# HIDEOUT, UTAH TOWN COUNCIL REGULAR MEETING

May 28, 2020

**Staff Report – Engineering Department  
Town of Hideout Planning Commission**

**Date:** April 28, 2020  
**Applicant:** Nate Brockbank  
**Subject:** Deer Springs Phase 1 Plans – Amended  
**Recommendation:** Final Approval

OFF-SITE WATER LINE - NORTH  
END AND CASINGS

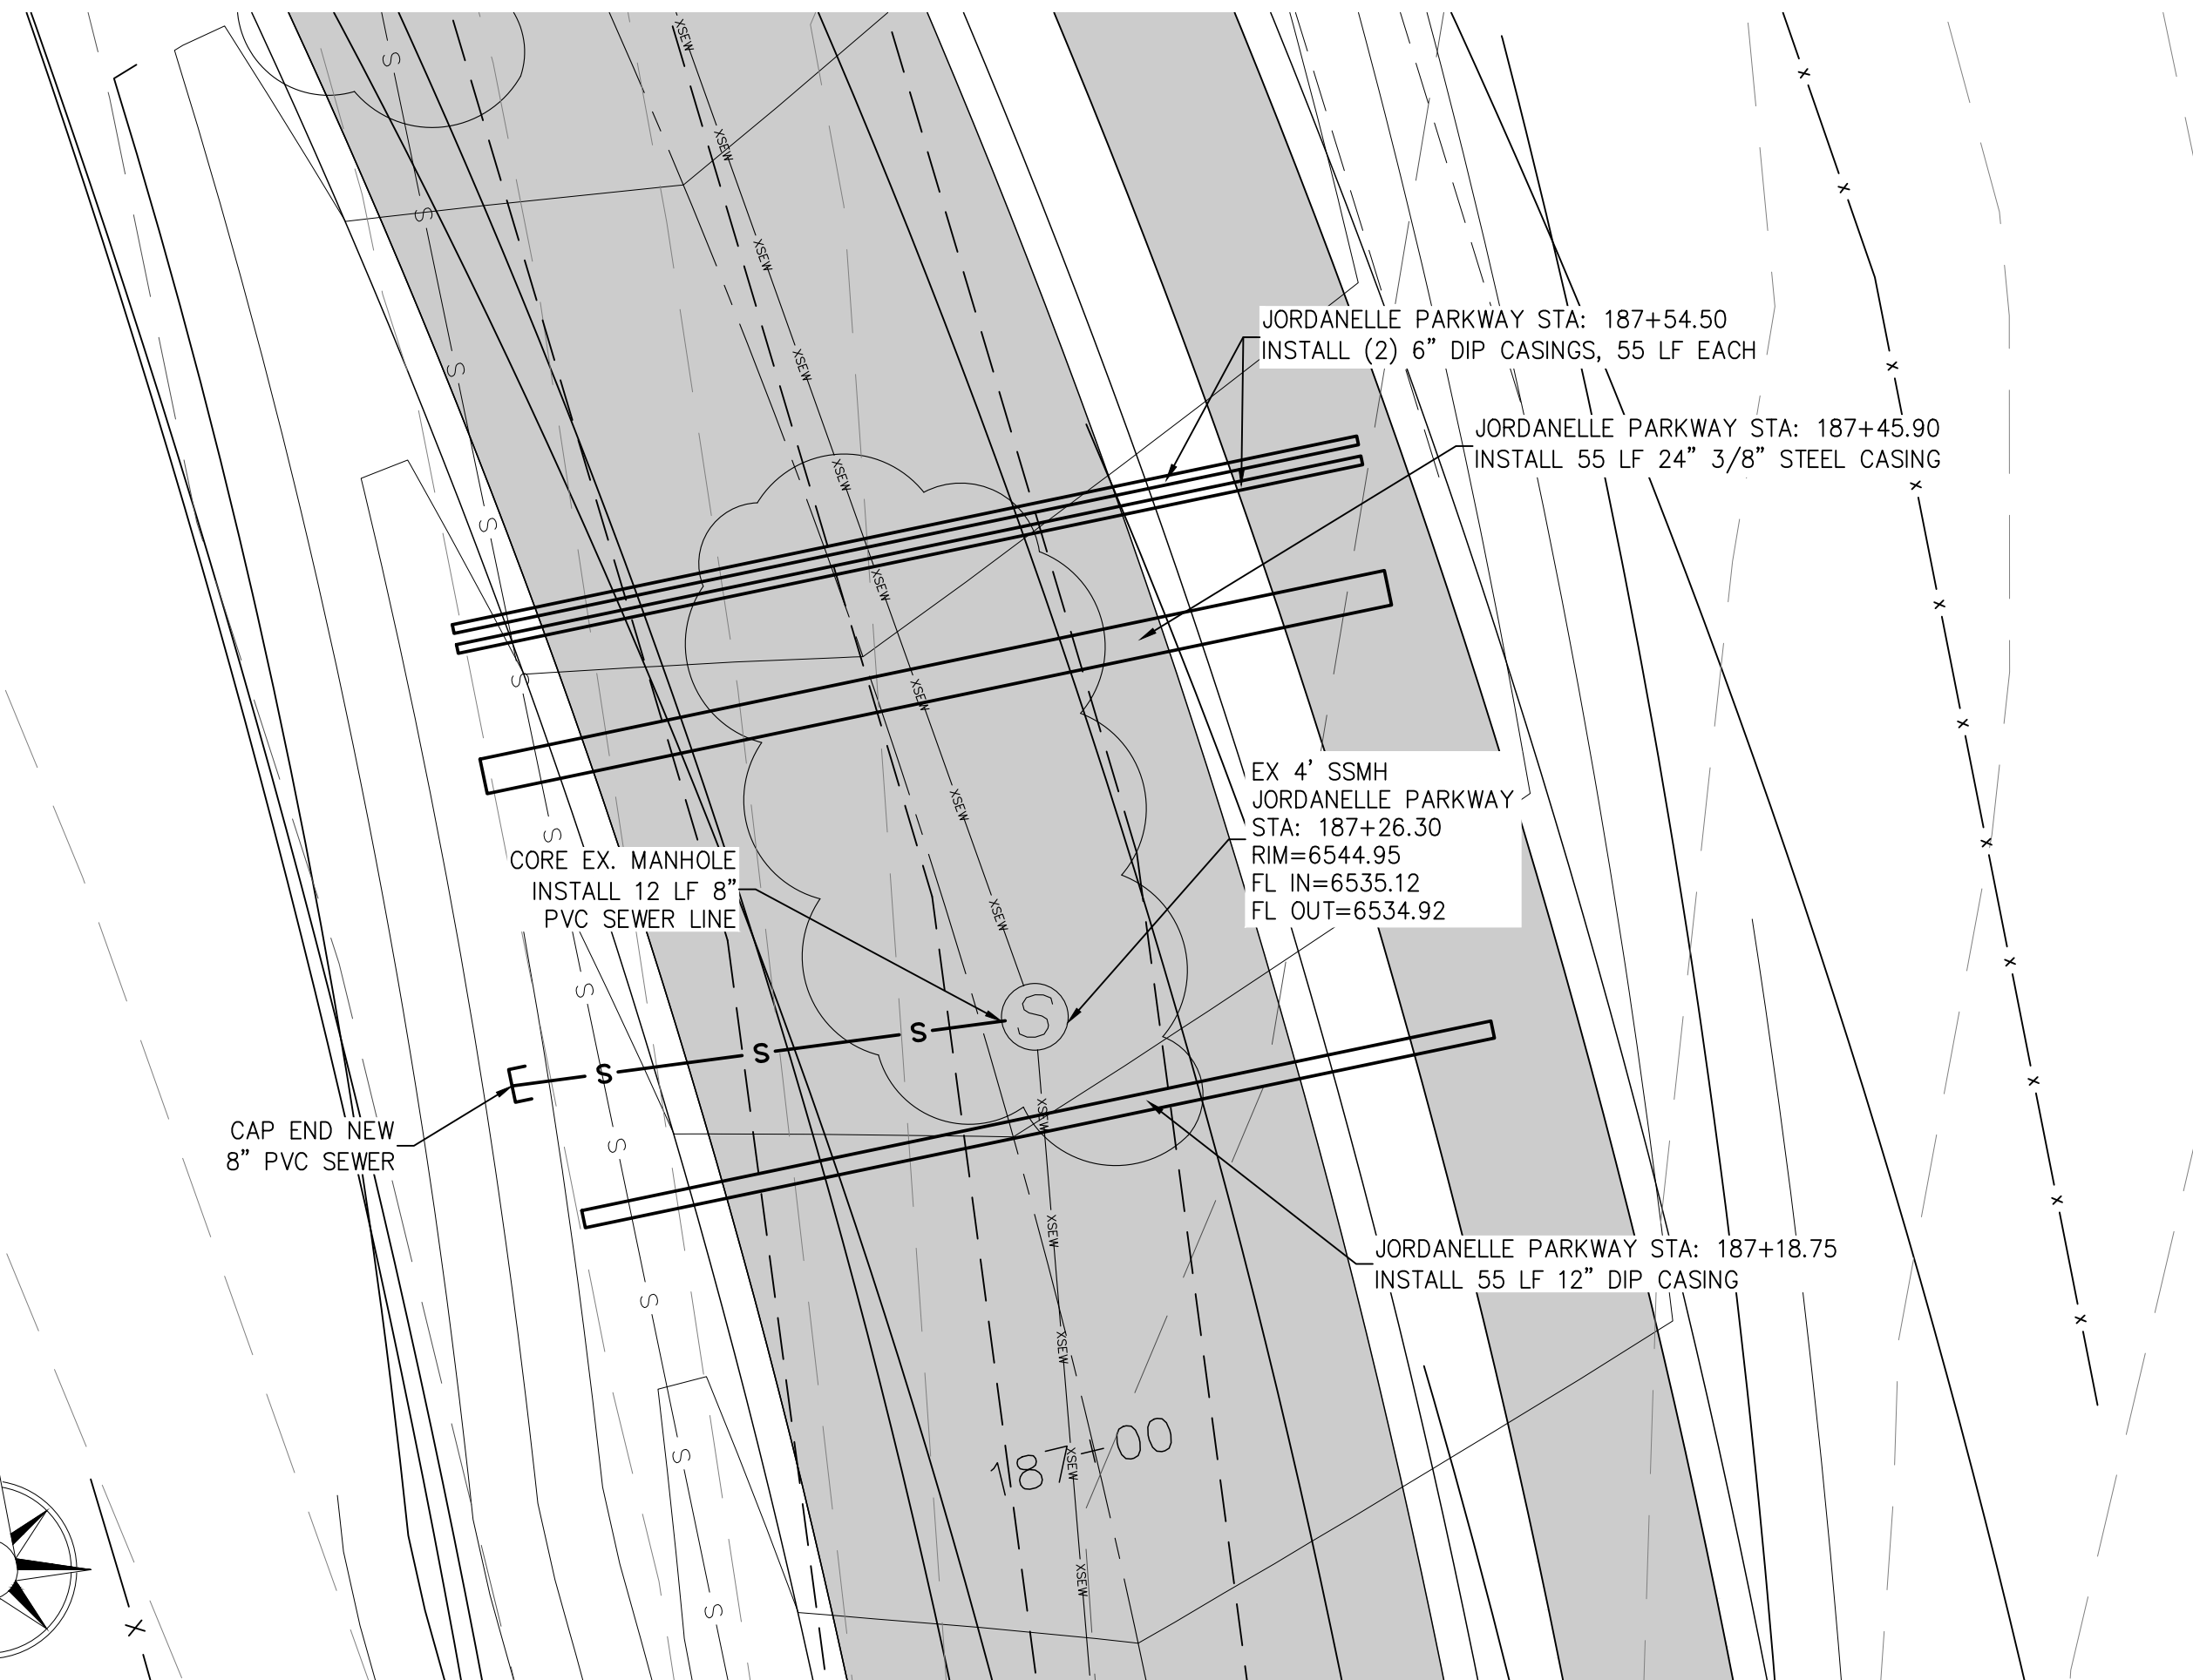
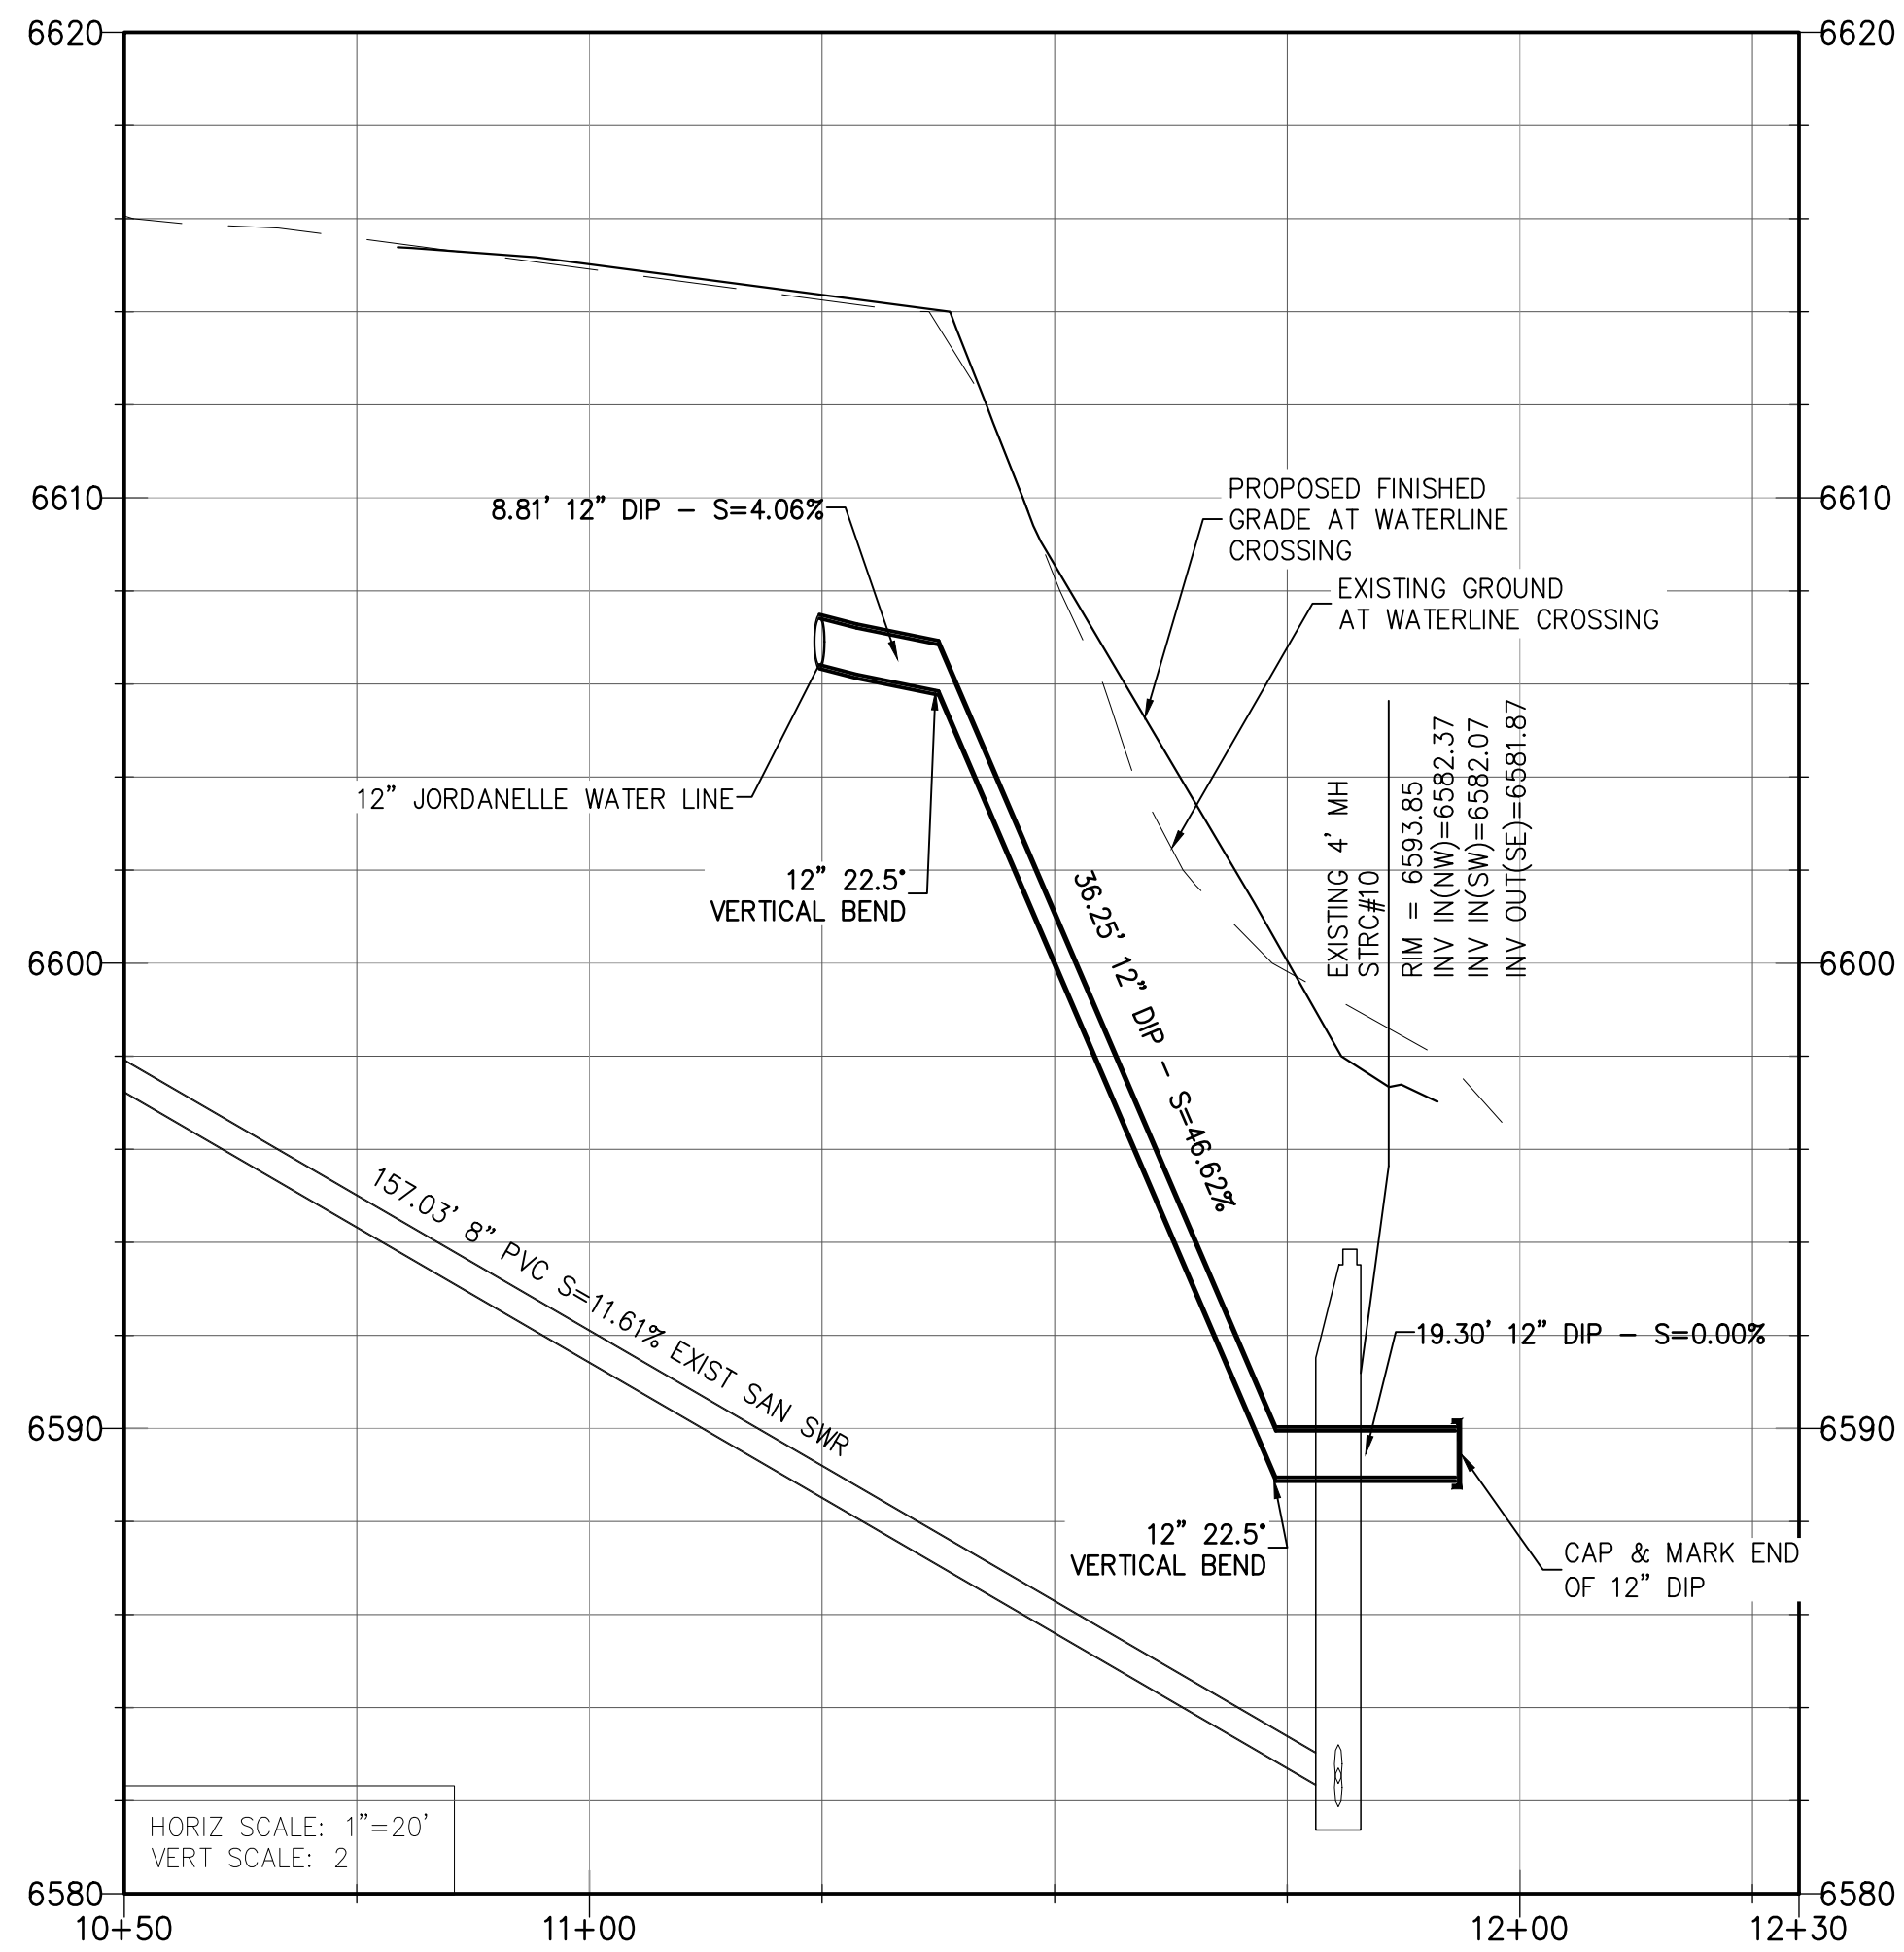
Pages PP1.4 through PP1.6 include details on placement of casings under Jordanelle Parkway for future connection. We understand that the placement of these connections and stub-out from Jordanelle Parkway is time-sensitive. However, a full plan set must be submitted and approved prior to construction of the roadway through the Deer Springs development to Jordanelle Parkway
